OAM and LPI Wake

Issues with OAM during Wake – pt 1/2

Comment – pt 1/2

Issues with OAM during Wake – pt 2/2

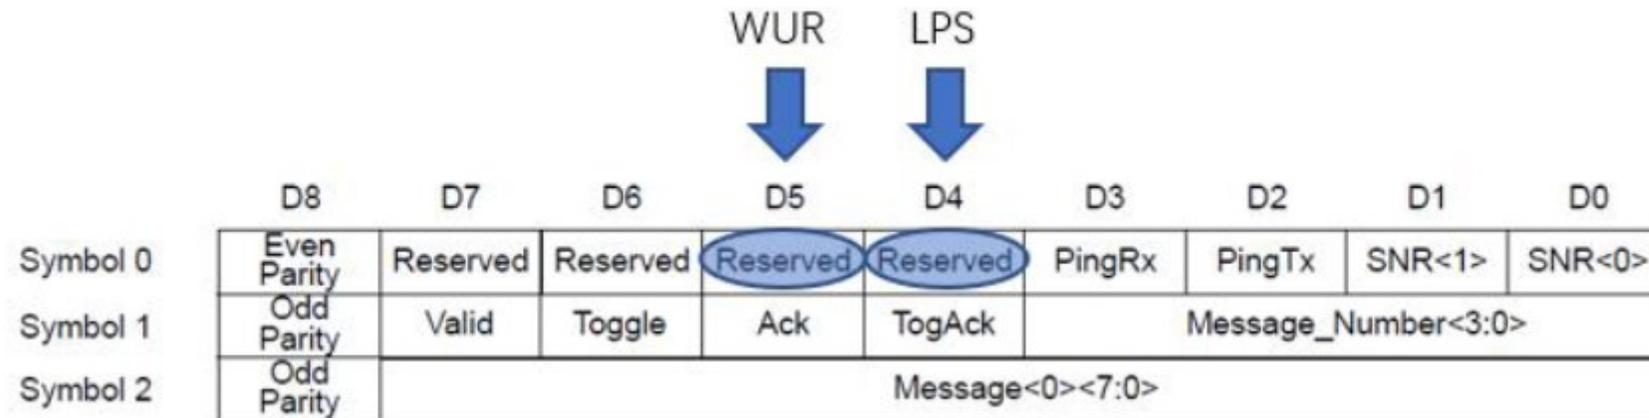
- It's difficult to predict what other uses will arise for OAM data
- Some future uses of OAM data may need the latency to be as low as possible
- We should ensure the OAM frame reliability during Wake
- Example 1000BASE-T1 TC10 uses OAM<0>[5:4] for WUR and LPS
 - OAM<0>[5:4] are not covered by the OAM ECC and don't utilize the OAM handshaking
 - The TC10 language states OAM<0>[5:4] is available for one frame
 - The LPS handshaking is slow and the latency penalty for missing an LPS is long

Solution: Insert 8 dummy OAM symbols during Wake frames

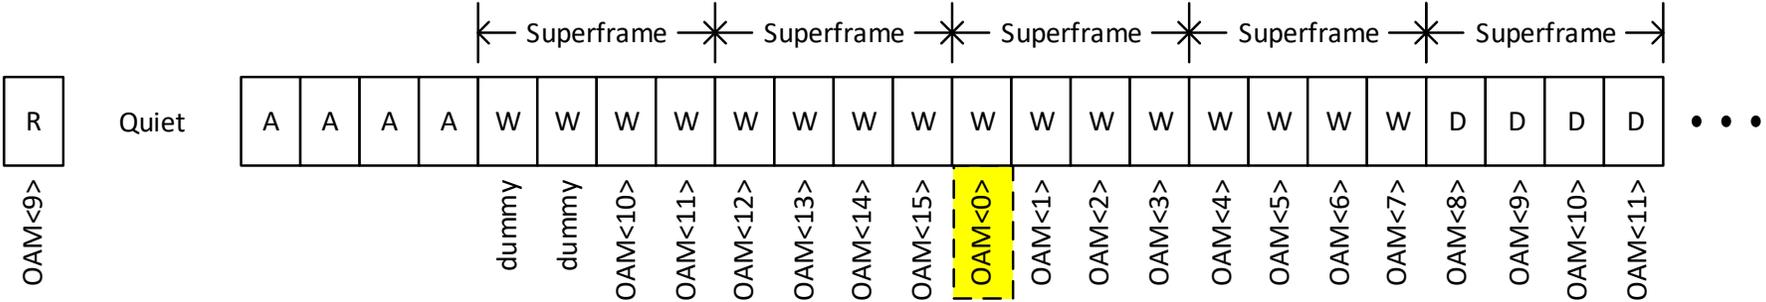
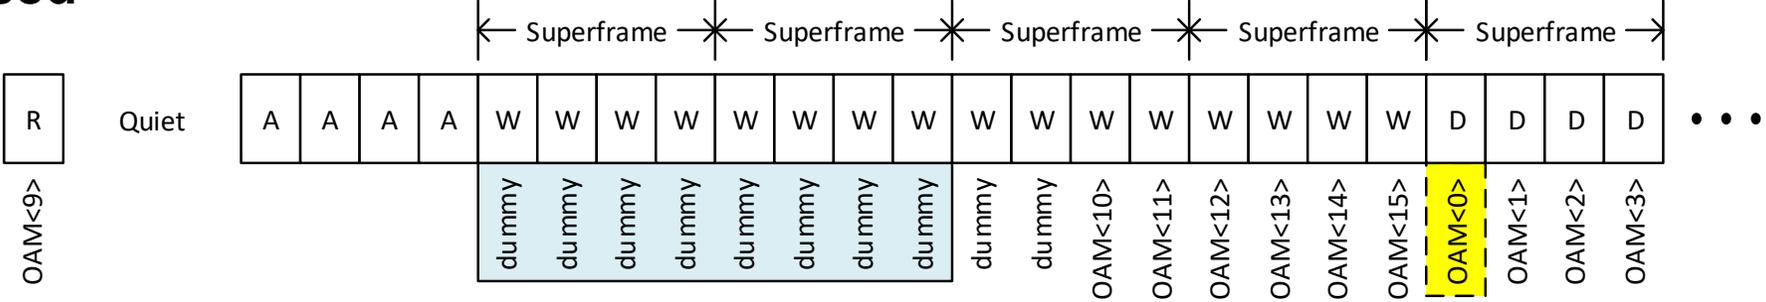
- Allows time for convergence
- Ensures OAM symbols have SNR similar to that of customer data
- Adds 2.66 us latency to decoding an OAM frame at the Wake transition

Current

Proposed

- Delete lines 34-39, page 88, in 165.3.9.2.1
- Replace with the following text from 802.3ch, page 126, in 149.3.9.2.1 with these insertions (underlined):

When transitioning from Low Power Idle to normal operation, it is possible that part of the OAM frame is sent over the LPI refreshes and the remainder of the OAM frame is packed in RS frames. In this case the first 8 frames of Wake shall contain dummy OAM symbols. After that, in some instances, it is possible that the remainder of the OAM frame cannot be aligned where the next OAM frame will have its first symbol (OAM<0>) inserted in the first RS frame of the superframe. In such cases, the partially transmitted OAM frame shall be interrupted according to the following rules:
